Amendments to the Drawings

REMARKS

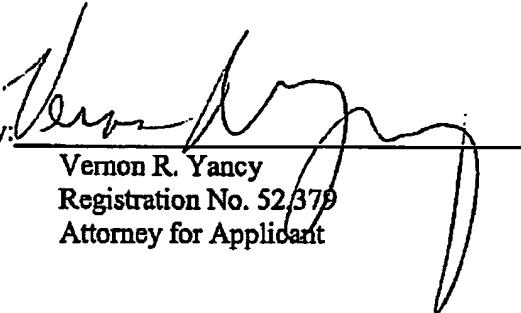
Figure 5 was objected to for including a multiplier symbol led by referenced numeral 420 that should have been a subtracter symbol. In addition, the drawings were objected to under 37 CFR 1.83(a) for not showing every feature of the claimed invention specified in the claims. Specifically, the "demodulator" and "error compensator" claimed in claim 36 were not shown in the drawings. In response, Applicants submit herewith replacement drawing sheets for FIGS. 2 and 5, providing the necessary corrections. FIG. 2, has been amended to illustrate a "demodulator" 201 as claimed in claim 36, and an "error compensator" 202, as claimed in claim 36. The changes to these figures are limited to the inclusion of the above referenced elements provided in the originally filed specification and claims. As such, no new matter is added. Having complied with the request set forth in the Action, Applicant respectfully requests withdrawal of the objection to the identified figures.
